REMARKS

APPENDIX A
MARKED UP VERSION OF DRAWINGS

FIG. 4

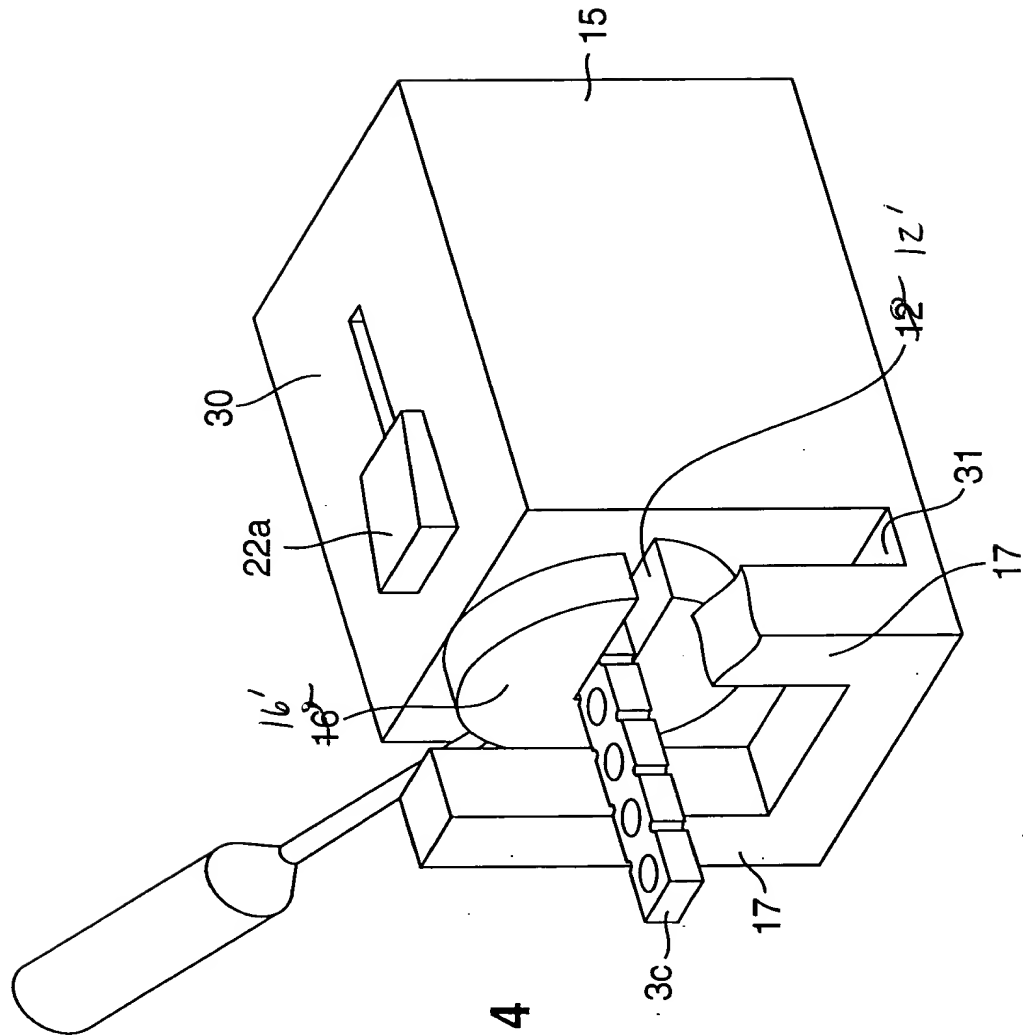
Applicants submit herewith six (6) sheets of formal drawings, reflecting drawing corrections to FIGS. 4 and 5, as requested by the Examiner. In the Office Action, the Examiner objected to FIG. 4 and FIG. 5, because numerals 12 and 16, "are modified versions of the previously shown slot component, and it seems that they should be changed to --12'-- and 16' or the like." (Office Action, page two, lines 14-15). In response, element numbers 12 and 16 in FIGS. 4 and 5 have been changed without prejudice to 12' and 16', respectively.

-- The tool shown in FIGS. 4 and 5 comprises a clamping mechanism 30 and a cutting unit 16' which is of the same general nature as that shown in FIGS. 2a-2c. As shown, the cutting unit 16' is inserted into a space 31 between a U-shaped entrance frame 17 and the casing 15 of clamping mechanism 30. As shown in FIGS. 4 and 5, a plate 3c to be cut is inserted through the U-shaped frame 17 through the aperture or slot 12' in cutting unit 16' and then into the clamping unit 30 through aperture 32.--
